New marking for helmet visors

Figure 1 – Position of the sticker on outside the visor

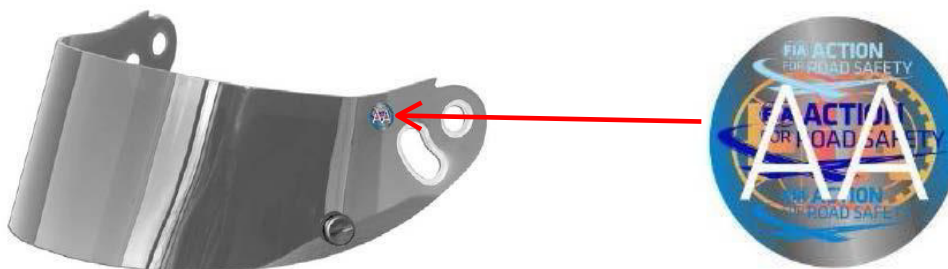
We would like to call your attention to a modification published in Appendix L (<http://www.fia.com/regulations>) related to a new marking for helmet visors. *Full visors fitted on the full face helmets, which are listed in Technical Lists N°33 (FIA standard 8860), 41 (FIA standard 8855) and 49 (FIA standard 8859) **must be labelled with an FIA sticker.***

- Visors manufactured **as from 01.01.2016** must have an FIA sticker;
- Visors manufactured **before 01.01.2016** do NOT have to be labelled with an FIA sticker and may still be used without one;

The FIA sticker is a holographic, 10mm diameter silver logo with two letters as Figure 2 and must be glued on the outside of the visor as indicated in Figure 1.
